PCI-SIG ENGINEERING CHANGE NOTICE

TITLE:	PASID Translation
DATE:	March 31, 2011
AFFECTED DOCUMENT:	Address Translation Services Specification, Version 1.1
SPONSOR:	AMD, HP

Figure 2-7: Translation Completion Data Entry

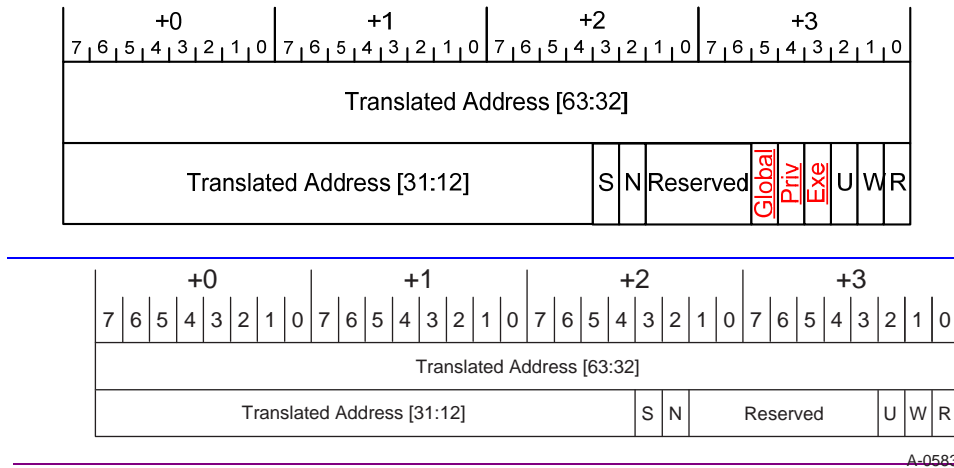
Section 2.3, modify Figure 2-7 to:

- 15
1. Define new bit “Exe” at byte 3 bit 3.
 2. Define new bit “Priv” at byte 3, bit 4.
 3. Define new bit “Global” at byte 3, bit 5.
 4. Shrink the reserved bits to byte 2, bit 1 through byte 3, bit 6.

Figure 3-2: Invalidate Request Message Body

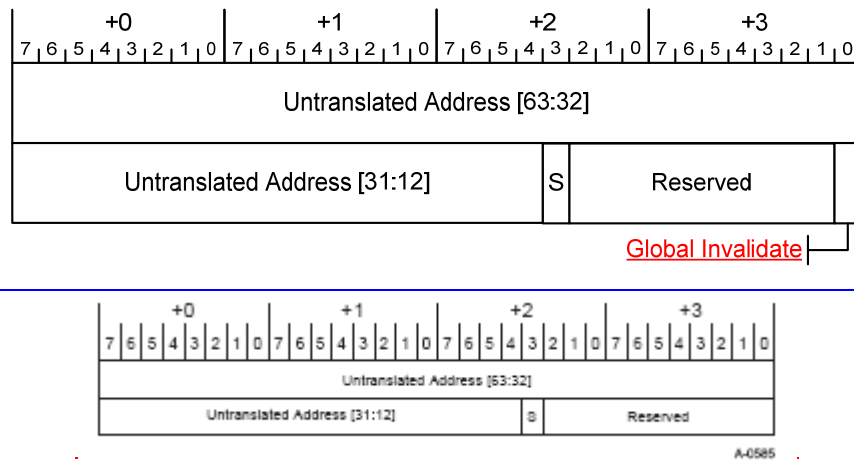
1. Modify Figure 3-2 to new "**Global Invalidate**" bit
2. Add new paragraph at the end of the section

The Global Invalidate bit indicates that the Invalidation Request Message affects all PASID values (see Section 3.8). This bit is Reserved unless the Invalidation Request has a PASID TLP Prefix. The bit is ignored by the ATC if Global Invalidate Supported bits is Clear (see Section 3.8).

Figure 4-1a: Stop Marker Message

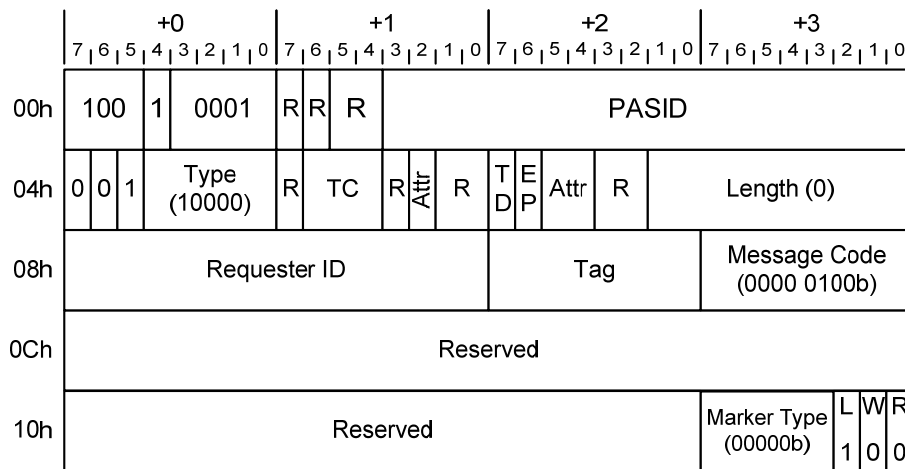
The Stop Marker Message bit layout is shown in Figure 4-1a.

A Stop Marker Message is encoded as a Page Request Message that contains a PASID TLP Prefix with the following exceptions:

- The L, W and R fields contain 1b, 0b and 0b respectively.
- The Untranslated Address field and upper bits of the PRG Index field are Reserved.
- The Marker Type field contains 00000b to indicate that this is a Stop Marker Message.
- The Execute Requested and Privileged Mode Requested bits in the PASID TLP Prefix are Reserved.
- The Traffic Class must be 0.
- The Relaxed Ordering attribute bit must be Clear.
- The ID Based Ordering attribute bit may be Set as specified in the *PCI Express Base Specification*.

Figure 5-3: ATS Capability Register

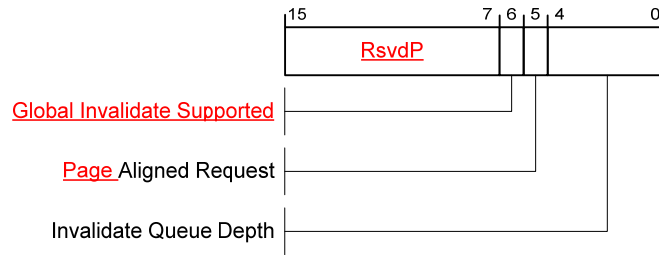
Section 5.1.2, modify Figure 5-3 to:

1. Correct name of bit 5 to **Page** Aligned Request (also noted in ATS Errata)
2. Change reserved bits 15:7 from RsvdZ to RsvdP
3. Define bit 6 as **Global Invalidate Supported**

Figure 5-8: Page Request Status Register

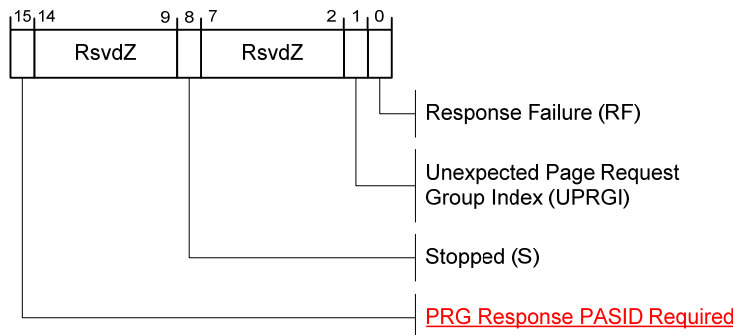
Section 5.2.3, modify Figure 5-8 to define bit 15 as PRG Response PASID Required

Bit Location	Register Description	Attributes
<u>15</u>	<u>PRG Response PASID Required</u> – If Set, the Function expects a PASID TLP Prefix on PRG Response Messages when the corresponding Page Requests had a PASID TLP Prefix. If Clear, the Function does not expect PASID TLP Prefixes on any PRG Response Message. Function behavior is undefined if this bit is Clear and the Function receives a PRG Response Message with a PASID TLP Prefix. Function behavior is undefined if this bit is Set and the Function receives a PRG Response Message with no PASID TLP Prefix when the corresponding Page Requests had a PASID TLP Prefix. This bit is RsvdZ if the Function does not support the PASID TLP Prefix.	<u>RO</u>
